RE: Re-estimation of Elevations
Within the Cohasset Flow

Enclosed are the revised 4 pages from the above report that contain a few changes. These changes were necessitated by the fact that the initial one-sided confidence interval as used by Taylor and subsequently used by me in the above report failed to take into account the joint probability of having both BFLT and TFLB satisfy the one-sided confidence interval at the same time.

Figure 12. Minimum difference in elevations at 64% confidence interval (Contour interval = 5')

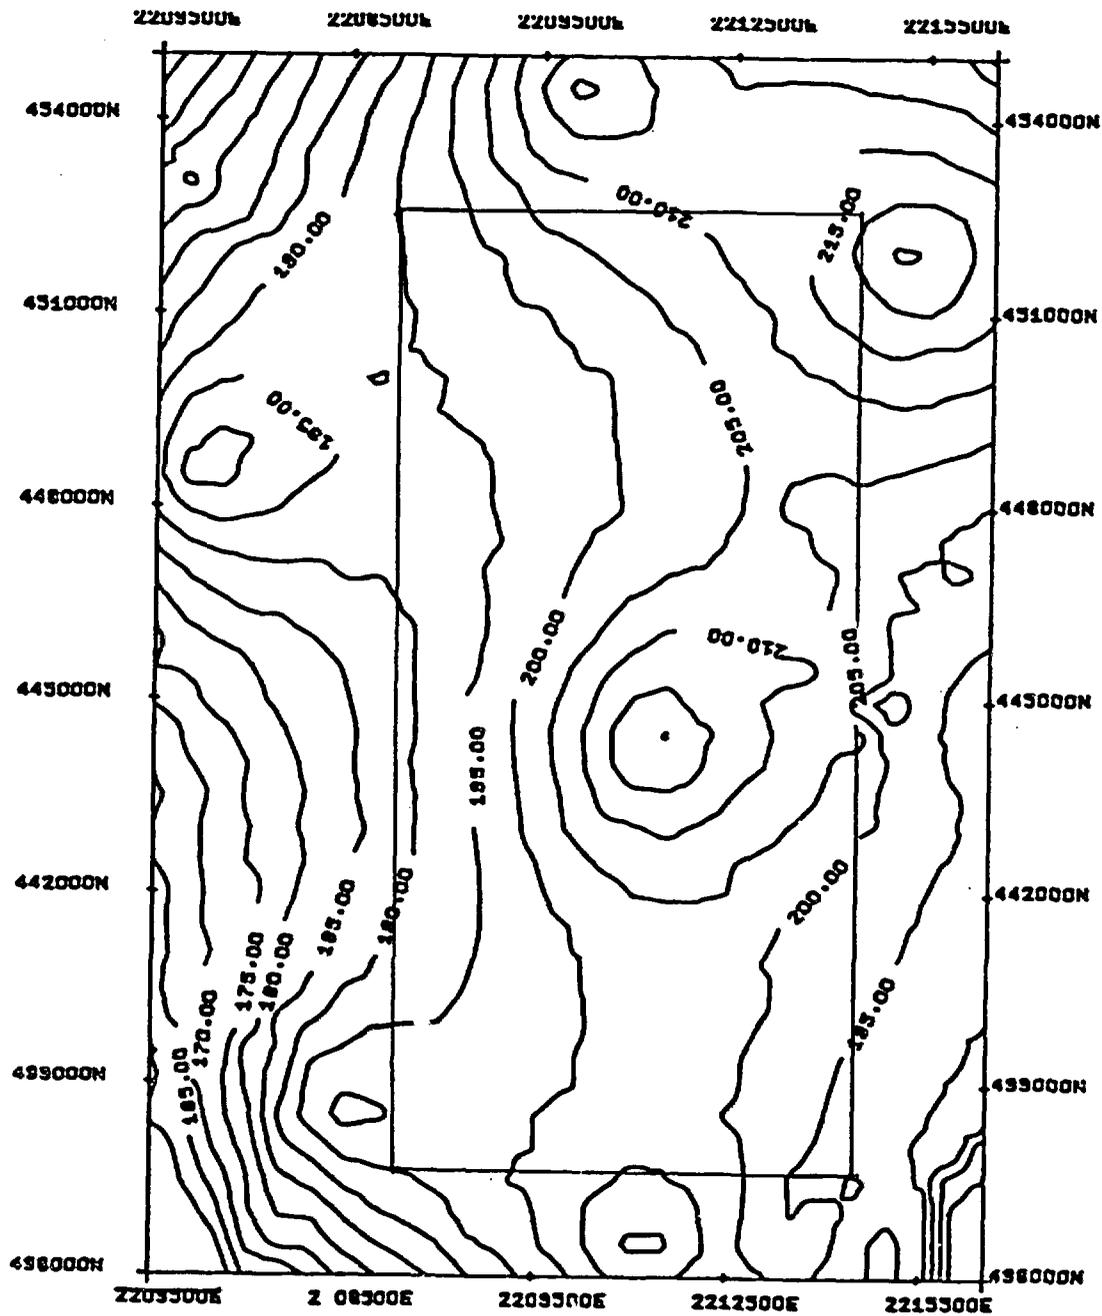
Figure 12 is the contour of the minimum differences at 64% confidence level assuming normality of errors and using one-sided rather than two-sided interval (i.e., $Z = 0.84$ in Eq.4). This 64% confidence level is based on the joint probability of having both BFLT and TFLB satisfy the 80% one sided confidence interval, i.e., $.80 \times .80 = .64$. (Please note that Taylor's 80% C.I. should be changed to 64% as well). From this figure, a minimum thickness of approximately 212' is found along the western edge of the repository layout area, which is different than Taylor's results (See Figure 19 on p. 33). At 90% ($.95 \times .95 = .90$) confidence, the minimum thickness is now reduced to approximately 188' which is still thick enough to satisfy buffer zone requirements of the repository design (See Figure 13).

$$\text{DIFFERENCE} = (\text{BFLT} - Z \cdot \text{KRIG1.STD}) - (\text{TFLB} + Z \cdot \text{KRIG2.STD}) \quad (4)$$
